SUBJECT: SAFETY EVALUATION OF EPRI REPORT, "BWR VESSEL AND INTERNALS PROJECT, CRACK GROWTH RATES IN IRRADIATED STAINLESS STEEL IN BWR INTERNAL COMPONENTS (BWRVIP-99)" (TAC NO. MB3951)

SAFETY EVALUATION OF THE "BWR VESSELS AND INTERNALS PROJECT,
"CRACK GROWTH RATES IN IRRADIATED STAINLESS STEEL
IN BWR INTERNAL COMPONENTS (BWRVIP-99)"

Figure 6
 Comparison of data with $B(K - K_0)^{1.1}$ fits

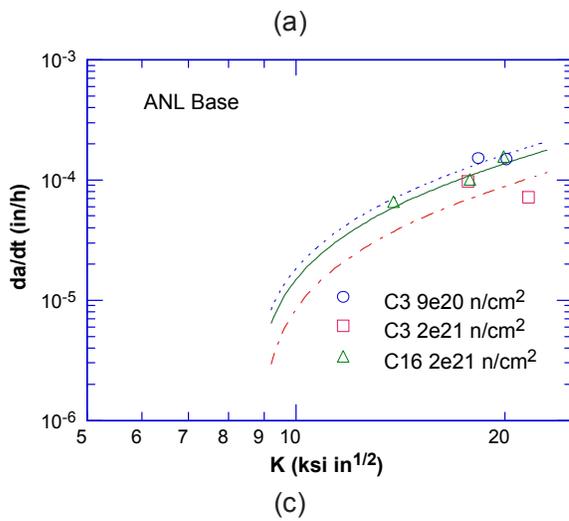
Equation 2 can be fit to the data for each specimen as before. To get a single parameter representation, K_0 was not chosen independently of B. Comparisons of the data with the curve fits are shown in Figure 6.

Because of the differences in the shape of the curves, it is not as easy to relate the BWRVIP-99 disposition curve to the population curves in this case. However, it is clear that the results are similar. For a substantial range of K, the disposition curve lies between the mean and 95th percentile curves. Also, despite the apparent differences in the forms of the equations, over the range of K of most interest, 12-20 ksi·in^{1/2}, the K dependence predicted by the Scott model form and BWRVIP models is similar.
